Noise Symptom - Buzzing Noises From the Door Panel Area: Replacing Covers on Power Windows Mechanism With New Type of Covers (SY 73/20)

Model Line: **911 Carrera (992)**

Subject: **Covers for power windows mechanism**

Cover for power windows mechanism

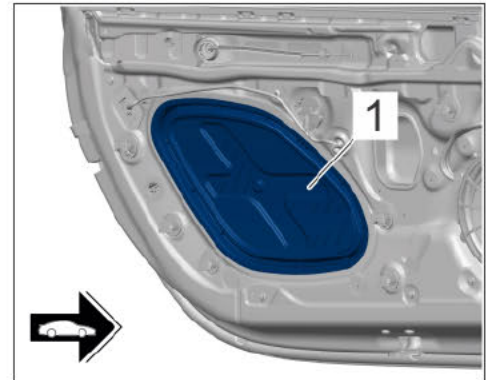
- 1 Unclip cover on power windows mechanism ⇒ *Cover for power windows mechanism -1-* using a suitable tool and replace it with a new type of cover.
